APPLICATION BY: U.S. ENVIRONMENTAL PROTECTION AGENCY 1445 ROSS AVE. DALLAS, TX 75202-2733	OFFICE OF COASTAL PROTECTION & RESTORATION RESTORATION ENGINEERING DIVISION 450 LAUREL STREET BATON ROUGE, LOUISIANA 70801	LAKE BORGNE SHORELINE PROTECTION	VICINITY MAP
DRAWN BY: KRISTI CANTU	DESIGNED BY: A. GONZALES-ROOLES	STATE PROJECT NUMBER: PO-30 FEDERAL PROJECT NUMBER: PO-30	DATE: NOVEMBER 2005 (REV. 11/2011) SHEET 1 OF 35

- PERMIT MODIFICATION NOTES:**
1. 3,750 LINEAR FEET OF ADDITIONAL SHEETPILE WILL BE PLACED LANDWARD OF FAILED SECTIONS OF THE CONSTRUCTED BREAKWATER ON REACH 1 AS SHOWN.
  2. ADDITIONAL ROCK WILL BE PLACED ON THE CONSTRUCTED BREAKWATER OF REACH 1 TO COMPLETE THE PREVIOUSLY PERMITTED MAINTENANCE LIFT.
  3. NO MODIFICATIONS ARE REQUIRED FOR REACH 2. PERMITTED WORK WAS CONSTRUCTED IN 2008. NO ADDITIONAL WORK IS NECESSARY FOR REACH 2.

LAKE BORGNE SHORELINE PROTECTION

SURVEY LAYOUT  
BAYOU DUPRE

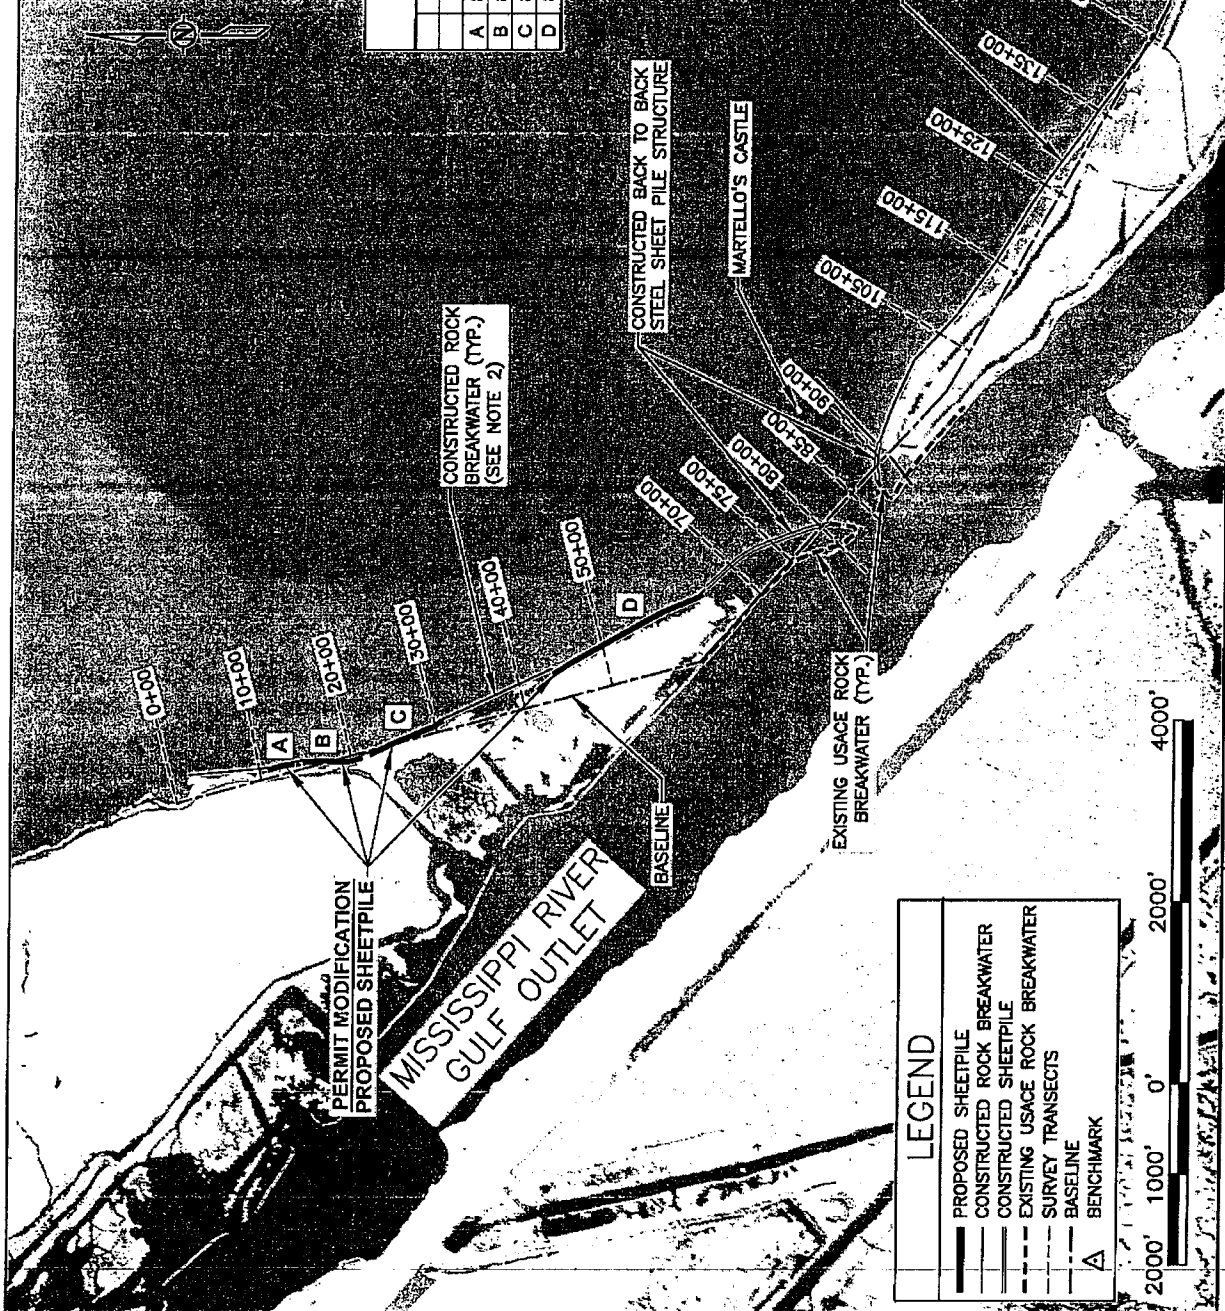
- 3,750 LINEAR FEET OF ADDITIONAL SHEETPILE WILL BE PLACED LANDWARD OF FAILED SECTIONS OF THE CONSTRUCTED BREAKWATER ON REACH 1 AS SHOWN.
- ADDITIONAL ROCK WILL BE PLACED ON THE CONSTRUCTED BREAKWATER OF REACH 1 TO COMPLETE THE PREVIOUSLY PERMITTED MAINTENANCE LIFT.
- NO MODIFICATIONS ARE REQUIRED FOR REACH 2. PERMITTED WORK WAS CONSTRUCTED IN 2008. NO ADDITIONAL WORK IS NECESSARY FOR REACH 2.

**SHEETPILE REACH COORDINATES**

NORTHWEST		SOUTHEAST	
	LONGITUDE	LATITUDE	LONGITUDE	LATITUDE
A	89° 50' 51.38"	29° 57' 40.80"	89° 50' 50.74"	29° 57' 37.89"
B	89° 50' 50.55"	29° 57' 36.93"	89° 50' 50.02"	29° 57' 30.32"
C	89° 50' 49.71"	29° 57' 29.56"	89° 50' 45.59"	29° 57' 21.31"
D	89° 50' 39.95"	29° 57' 9.34"	89° 50' 30.17"	29° 56' 53.00"

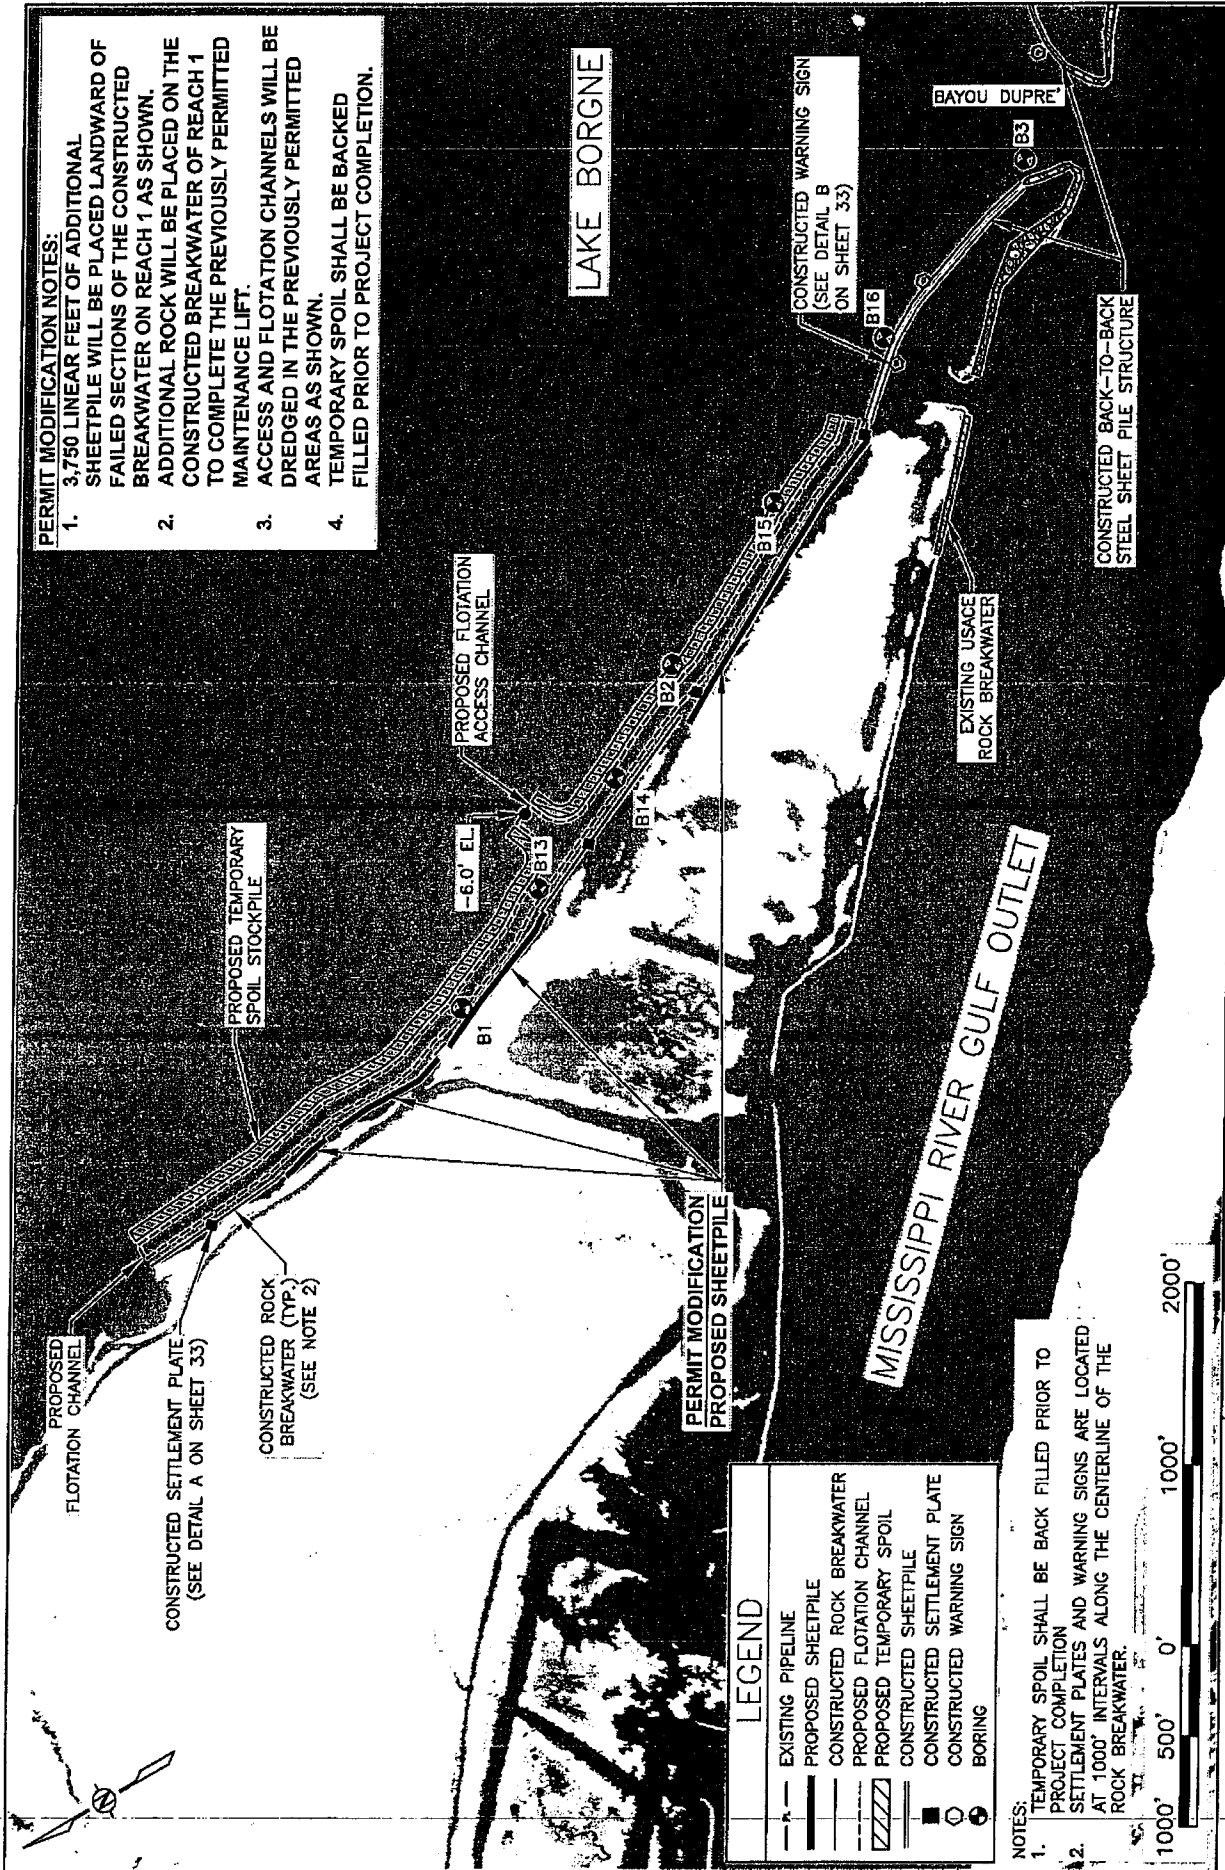
NO PERMIT MODIFICATIONS REQUIRED FOR REACH 2  
 PERMITTED WORK COMPLETED IN 2008.  
 NO ADDITIONAL WORK TO BE DONE.

BREAKWATER ALIGNMENT  
SHELL BEACH - REACH 3

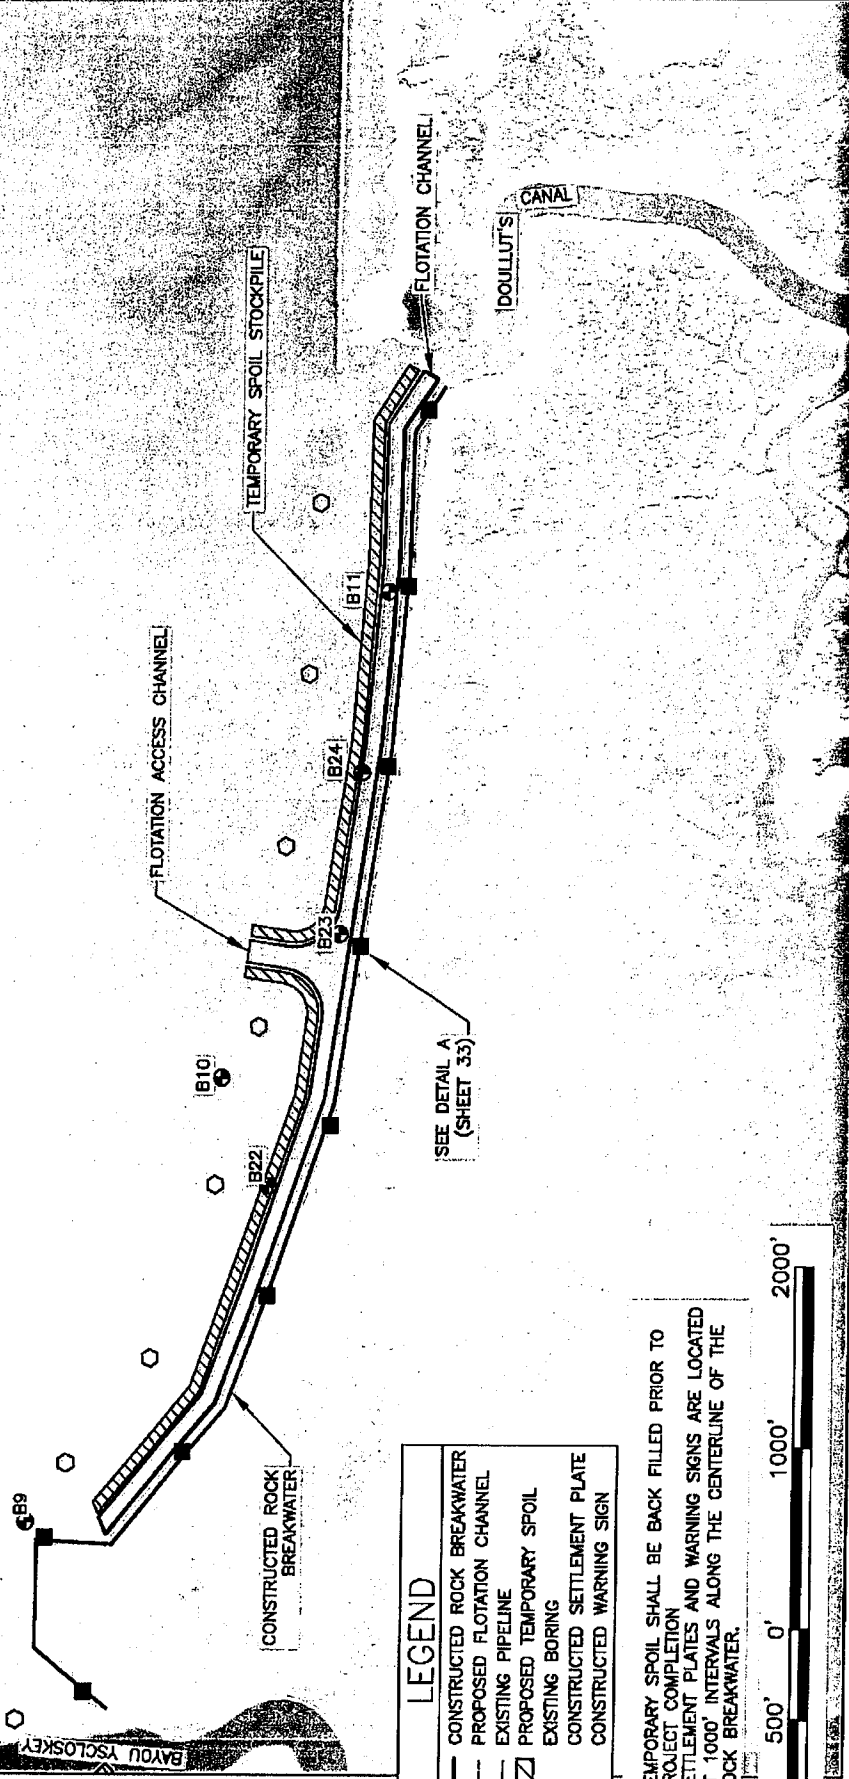
1. 760 LINEAR FEET OF ADDITIONAL SHEETPILE WILL BE PLACED LANDWARD OF FAILED SECTIONS OF THE CONSTRUCTED BREAKWATER ON REACH 3 AS SHOWN.
2. ADDITIONAL ROCK WILL BE PLACED ON THE CONSTRUCTED BREAKWATER OF THE EASTERN PORTION OF REACH 3 TO COMPLETE THE PREVIOUSLY PERMITTED MAINTENANCE LIFT.
3. NO MODIFICATIONS ARE REQUIRED FOR REACH 4.
4. PERMITTED WORK WAS CONSTRUCTED IN 2005. NO ADDITIONAL WORK IS NECESSARY FOR REACH 4.

CONSTRUCTED ROCK BREAKWATER (SEE NOTE 2)

PERMIT MODIFICATION PROPOSED SHEETPILE

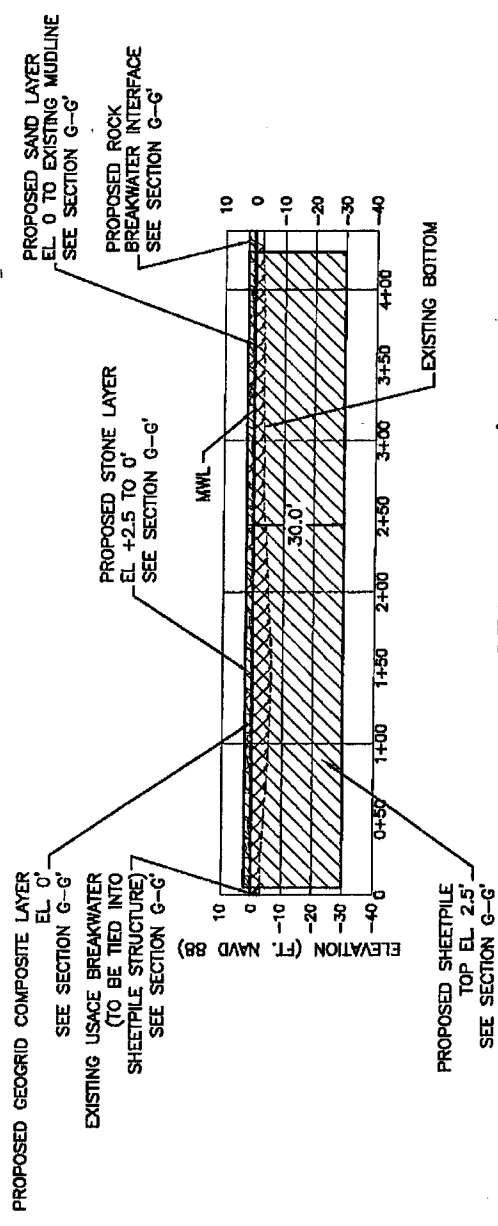
**SECTION E-E'**  
 PROPOSED BACK-TO-BACK STEEL SHEET PILE  
 STRUCTURE FOR REACH 1  
 (NOT TO SCALE)

**SECTION F-F'**  
 PROPOSED BACK-TO-BACK STEEL SHEET PILE  
 STRUCTURE FOR REACH 2  
 (NOT TO SCALE)
